Government of Madras.

*Public Works* DEPARTMENT.  
*Can 315/59*

*Proceedings of the Madras Government Public Works Department  
from 30th April to 3rd May 1859.*

No. 48. Read the following letter from Colonel C. E. FABER, Chief Engineer ; to J. D. BOURDILLON, Esq., Secretary to Government, dated 6th April 1859, No. 9385.

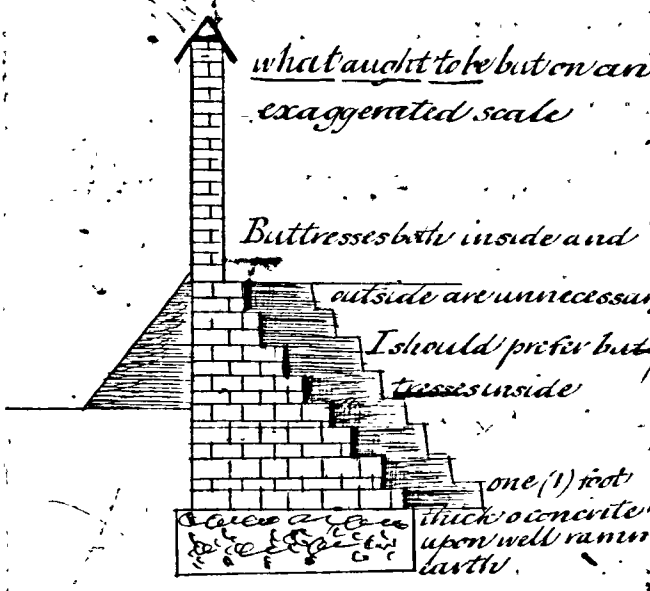
has been disturbed as it will be seen in plan. I will here break away for the short time from the thread of my story to offer some remarks which occur to me. viz. I & Mr. Saccelles was determined that the Jail should not be built where it was secondly proposed but near this laterite hill for public reasons. It is noted for changing the site have not come to my knowledge why not.

Build it on the perfectly level plateau on top of the hill AB. The tops of nearly all the laterite Hills near the coast in Canara are mathematically speaking perfectly horizontal planes. I cannot conceive the public grounds upon which the present site was chosen. If it be urged that the Jail was built on the hill side to avoid the severity of the Monsoon I oppose the argument by noting that you do not obtain shelter from a western Monsoon by building on the western face of a hill so that argument falls to the ground. It may be argued that the prisoners have not to draw water from such a depth.

depth of 2 or 3 feet, but this is all very unsatisfactory argument. The side of a laterite hill (laterite being very porous and spongelike is damp not only during the rains but also during a portion of the dry weather, whereas the top of a laterite hill is truly never damp and I appeal to any one who knows Canara to support me. Here we will again bear the contents of para 5 in mind. Now in an Engineering point of view the top of the laterite hill, viz: a horizontal plane of laterite stone would have been an almost imperishable foundation, I should fancy: but for some reasons best known to Mr Lascelles & the change from No 1 site to No 2 was I believe proposed by the then Zilla Engineer upon sanitary grounds and he proposed to build on the level plateau, referred to in para 5 overlooking Mr Lascelles' ground and then Mr Lascelles proposed No 3 site. & he manoeuvred so as to have the Jail erected on its present site on "disturbed" and "made" soil by & I opine, an Officer deficient in extensive practical experience as to the best method of dealing with foundations in prepared soil &c and behold the result: a tumble down affair from top to bottom is the New Jail at Honore.

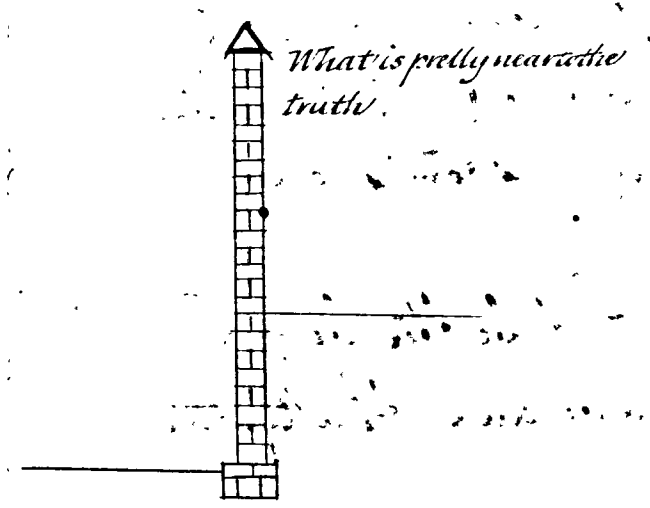
7. The roofing are much too heavy, and the walls not sufficiently thick, abutments have not been resorted to where they are much wanted a reference to the Marginal sketch of what

is and what ought to be, may render my explanation more intelligible. The earth was not laid down it is said; & all my statements are unsupported by documentary evidence & a footing of one foot deep having been excavated walls were run up on the disturbed earth in mud (laterite in mud!!!) to a height in some cases of 20 or 30 feet.

feet. The wall being I am informed two feet thick at bottom in the special instance here quoted. This was madness if it be true. Major Macdonnell I believe executed this part of the work and it appears to me from what I have seen that the statements made to me are about the truth.

11 The mischief is bad enough alone for the present and begins radically to correct the faults of this Building after the Monsoon. The whole of the enclosing wall to begin with, must be removed and foundations re-excavated rammed and laid with concrete: say at least a foot thick and proper substantial walls of laterite in Cannam & with buttresses where the walls are of the nature of revetments & substituted for the present brown paper affairs of laterite in mud. The guard houses will have to come down perhaps, also revetments between the upper and lower areas. Much of the roofing is too heavy.
